UNITED STATES PATENT AND TRADEMARK OFFICE

APPLICATION NO.	FILING DATE	FIRST NAMED INVENTOR	ATTORNEY DOCKET NO.	CONFIRMATION NO.
10/066,066	01/31/2002	Robert W. Aukerman	P 1028.11004	2497

Office Action Summary

DETAILED ACTION***Drawings***

U.S. Patent Jan. 13, 2004 Sheet 2 of 2 US 6,176,184 B1

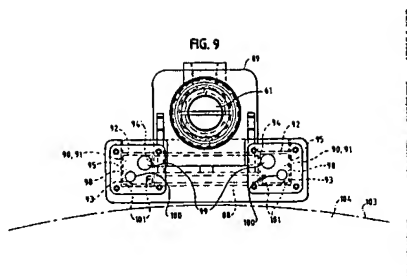
- {claim 1} An ink drying system (column 1, lines 5-9), coupled to a source of pressurized gas (figure 2, references 41, 57),

and comprising a plurality of plenums (figure 9, references 90),

each plenum including an associated plurality of orifices (figure 9, reference 101); a plurality of fluid flow valves for controlling fluid communication between the plenums and the source of pressurized gas (figure 2, reference 42); a controller (figure 2, reference 56; column 3, lines 29-52)

- {claim 2} drying portions provide substantially complete laterally extending coverage of the sheet (figure 2, references 39, 43 W; column 4, lines 63-67) and wherein the drying portion of at least one of the plenums provides a substantially different range of laterally extending coverage of the sheet than at least one other of the plenums (figure 9, references 90)
- {claim 3} at least two of the plenums are spaced substantially apart from one another in a direction of travel of the sheet by a predetermined distance (figure 9, references 90; column 4, lines 42-52) and wherein the drying portions of the plenums are each substantially laterally co-extensive (figure 9, references 90; column 4, lines 63-67; column 5, lines 1-2)
